Lead Local Flood Authority

Consultation Response

Application number: S/COND/22/0711

Proposal: Discharge of conditions 40 (Flood Mitigation) and 41 (Surface Water - Full Site) from Outline Planning Permission S/OUT/13/1555

Figure 2 - 1335-DR-03 Rev G Redirection of Surface Water Flow route

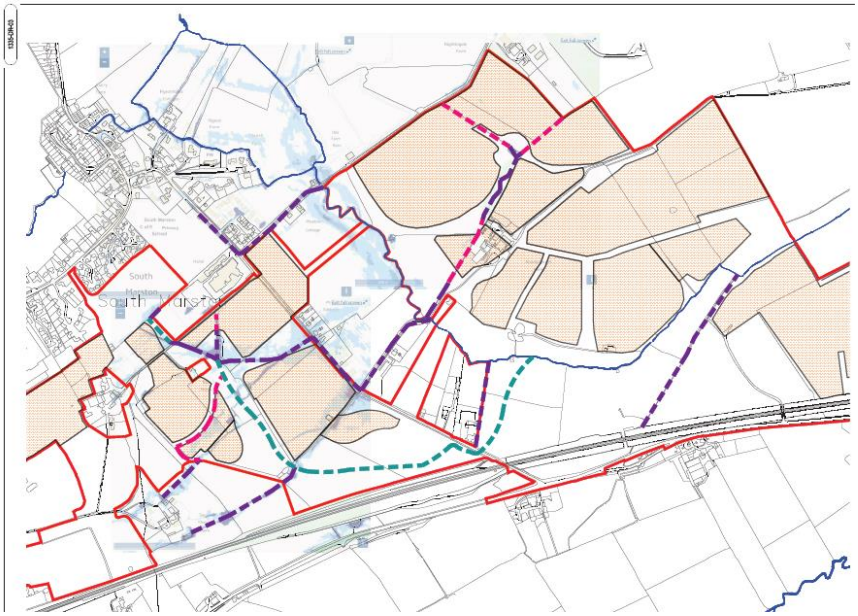
The key drainage routes were shown on the approved outline plan 1335-DR-03 Rev G shown in Figure 2 below.

The existing ditches must be retained or can be diverted through adequate above ground features.

A commitment has been made to retaining and enhancing the key existing ditch/swale network to manage the flows in the South Marston area but this is not being done in the Rowborough area.

This key strategic network must be provided and the strategy must go further in discharging flows throughout the network rather than only a few discharge points via large ponds, to ensure the existing drainage regime is maintained inline with local and national guidance.
